Moorebank Precinct East Stage 2 – MOD 3

Response to Submissions -
(SSD 7628 Mod 3)

Moorebank Precinct East Stage 2 Mod 3 Response to Submissions Report –SSD 7628 Mod 3

Figure 2: MARW alignment in relation to MPE subdivision lot boundaries (Source: EMM, 2020)

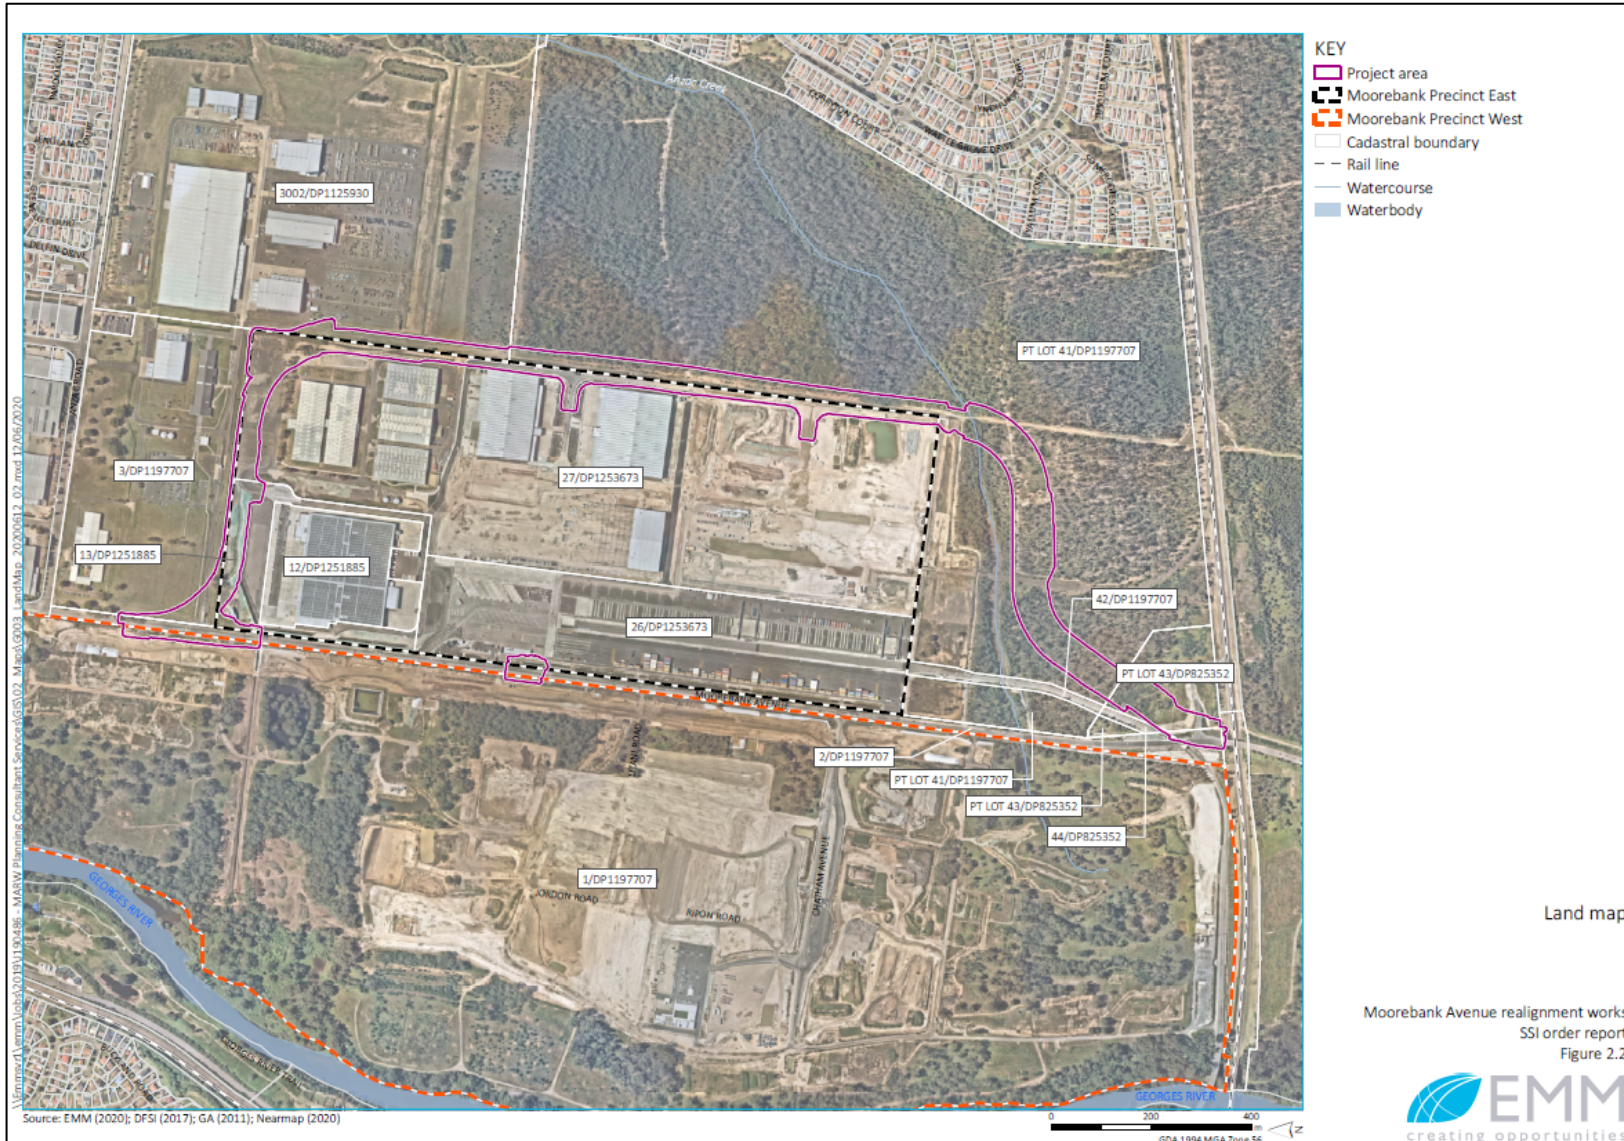
No information was provided regarding the potential impact of the proposed Modification on the Moorebank Avenue Realignment proposal. How has the potential impacts of the proposed Modification on the Moorebank Avenue Realignment proposal been assessed.

The Proposed Modification has no impacts on the proposed Moorebank Avenue Realignment (MARW), as:

- No physical works are proposed.
- The subdivision aims to provide certainty in terms of land ownership and management responsibilities in respect of the already approved dedicated rail access corridor. This will facilitate management and operation of MPE and in particular the Terminal lot as sought by the MPE Concept Approval (MP10_1093) future assessment requirements for subdivision. This arrangement is preferred over having an easement as it will provide clear management responsibility for respective lots. This is likely to have beneficial impacts on MARW throughout the construction and operational phase.

- The proposed MARW alignment enters and exits the Boot Land (Lot 4 DP1197707) without conflicting with the proposed rail corridor lot (Lot 42 in Table 1 and currently Easement G). The impact on this lot is unchanged with or without the proposed Modification.
- The proposed MARW alignment enters the Railcorp site (Lot 1 DP825352) without conflicting with the proposed rail corridor (Lot 44 in Table 1) and joins Moorebank Avenue north of the East Hills Railway. This junction is subject to detailed design and may encroach on proposed Lot 44. This encroachment will not impact on future development of the MARW, nor will it conflict with Lot 44 use as a rail corridor for effective management and operation of the MPE IMEX Terminal lot.

Figure 2 provides a plan of the proposed MARW alignment with respect to existing lot boundaries.

Figure 3 : MITRA Strategy Concept Plan (Source: TfNSW <https://www.rms.nsw.gov.au/projects/cambridge-ave-glenfield-upgrade/index.html>, 2020)

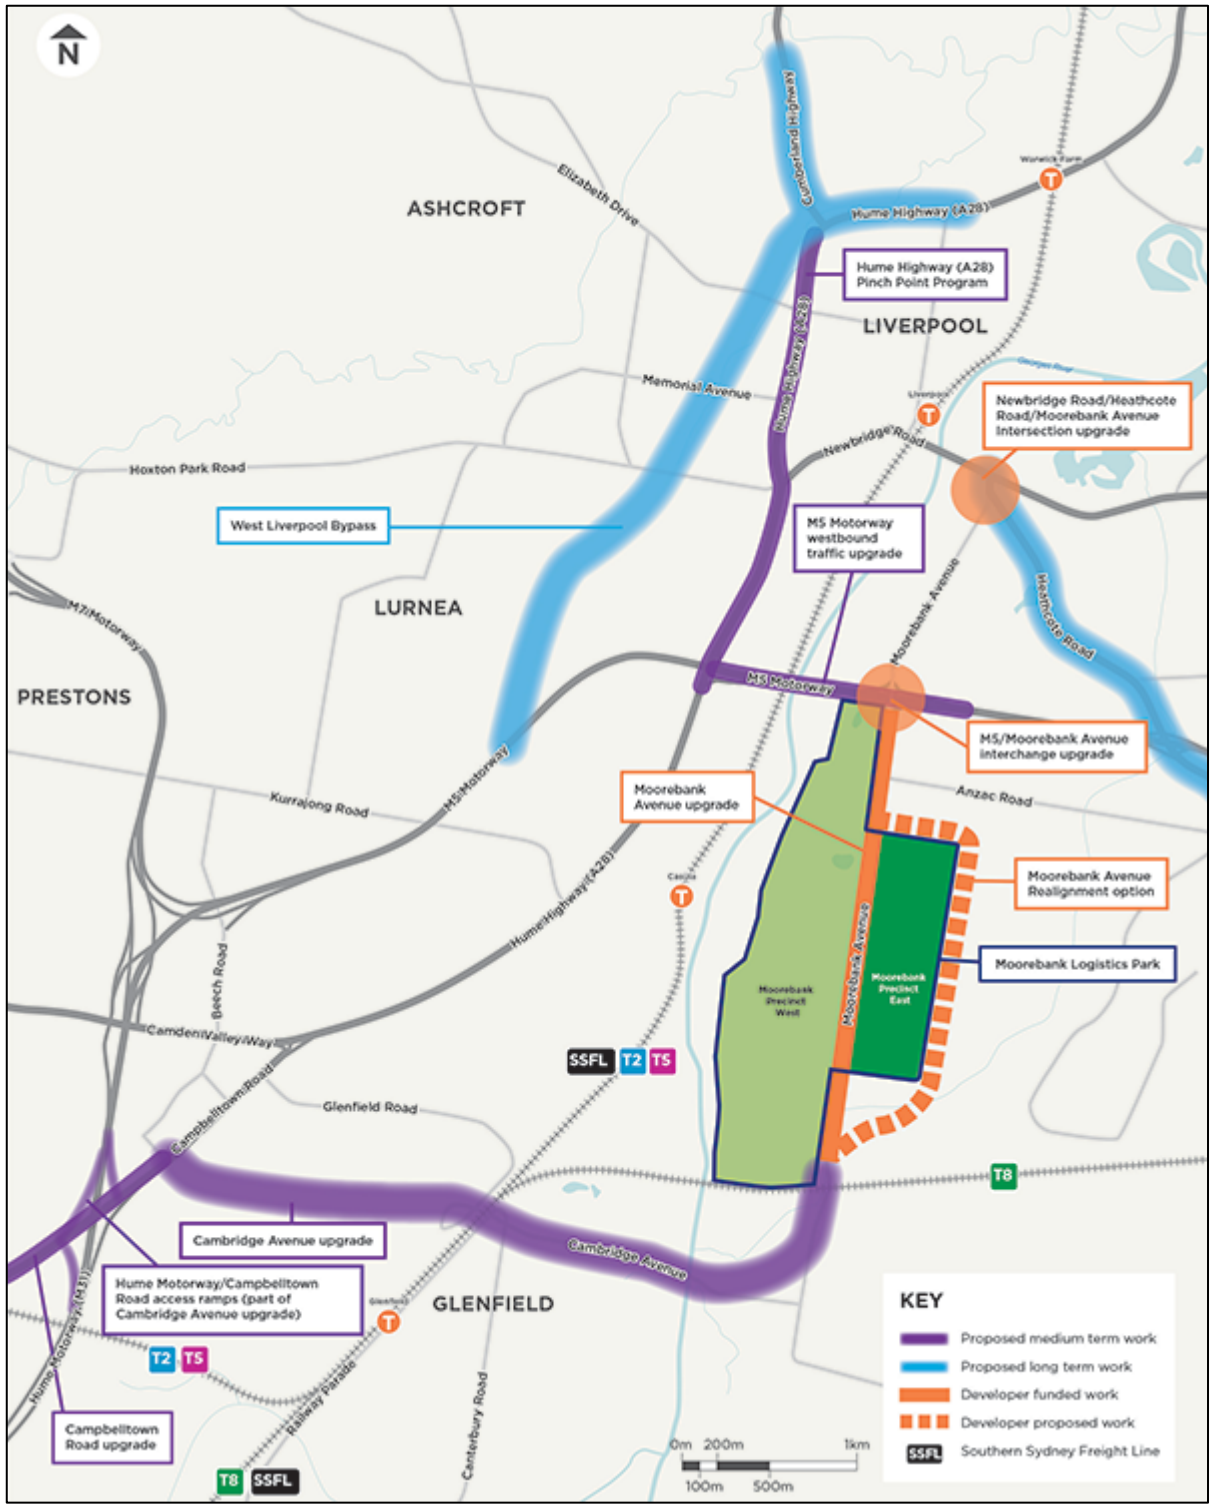
2. *No information provided regarding the potential impacts of the proposed Modification on the Cambridge Avenue upgrade proposal. The Modification should not preclude TfNSW ability to connect the proposed Cambridge Avenue upgrade to either the MARW, or if that does not proceed, the Moorebank Avenue Upgrade. How have the potential impacts of the proposed Modification on the conjunction of the MARW or Moorebank Avenue Upgrade and the Cambridge Avenue upgrade been assessed.*

Based on review of available information on the Moorebank Intermodal Terminal Road Access (MITRA) Strategy, the concept design indicates that the Cambridge Avenue upgrade would join Moorebank Avenue north of the East Hills Rail Corridor, in the approximate location of the junction with MARW (Figure 3).

The Modification is for changes to the MPE subdivision layout and compliance reporting frequency only. The Cambridge Avenue upgrade works appear to be outside the footprint of the proposed subdivision and so would not have any implications on these works.

The subdivision of Lot 1 DP825352 and Lot 4 DP1197707 will result in the change of ownership of the resultant rail corridor lots (i.e. Lot 42 and 44 in Table 1), however, this will not preclude TfNSW's ability to connect Cambridge Avenue to MARW (or the Moorebank Avenue upgrade, should MARW not proceed). Lot ownership of the residual lots will remain unchanged.
